MEMORANDUM

SUBJECT: Record Notes - FEA Comments - Yucca Mountain

YUCCA MOUNTAIN REPOSITORY AREA

Figure 3-8. Generalized outlines of the primary repository and possible expansion areas. Modified from Mansure and Ortiz (1984).

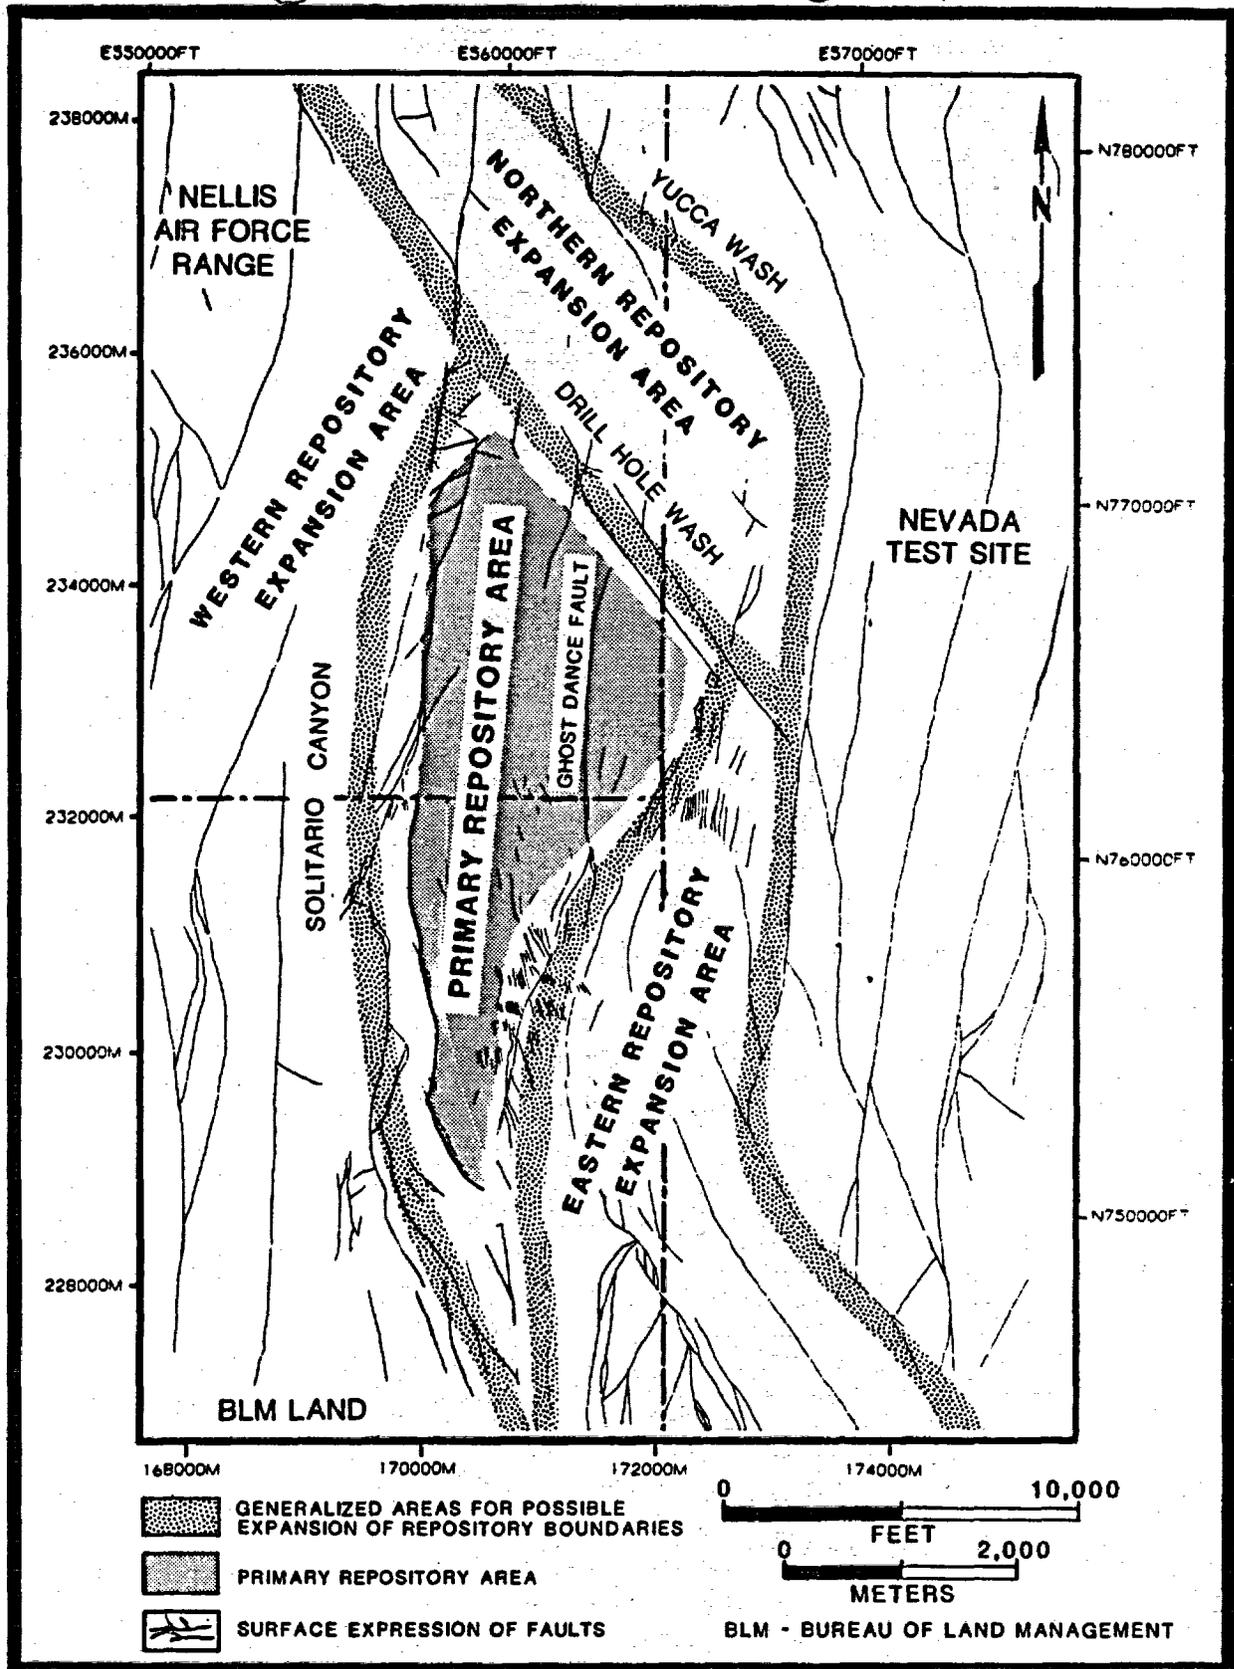
The geologic sections and maps presented in the FEA can be interpreted as of only minimal concern with a few such features intersecting the repository horizon and occurring near the boundaries proposed for the primary repository area. A brief review of the geologic sections and map of the area [Figures 3-7 and 3-8 of the FEA] indicate a distinct possibility that an oversimplification is presented relative to the lateral flexibility. The "Ghost Dance Fault" is depicted as a nearly singular feature transgressing the repository area and with limited vertical displacement designated on the geologic section.

It is therefore of engineering concern that other faults that can be readily projected across and through the primary repository area may have similar or greater vertical offsets and therefore result in a step-like geometric configuration of the particular horizon level of interest for the repository. This is a condition that can be readily assessed from an engineering geological standpoint by closely-spaced drillholes along selected traverses, high-resolution geophysical logging of the drillholes, and surficial geophysical profiling of shallow marker horizons that can be related geologically to the deeper repository level of interest.
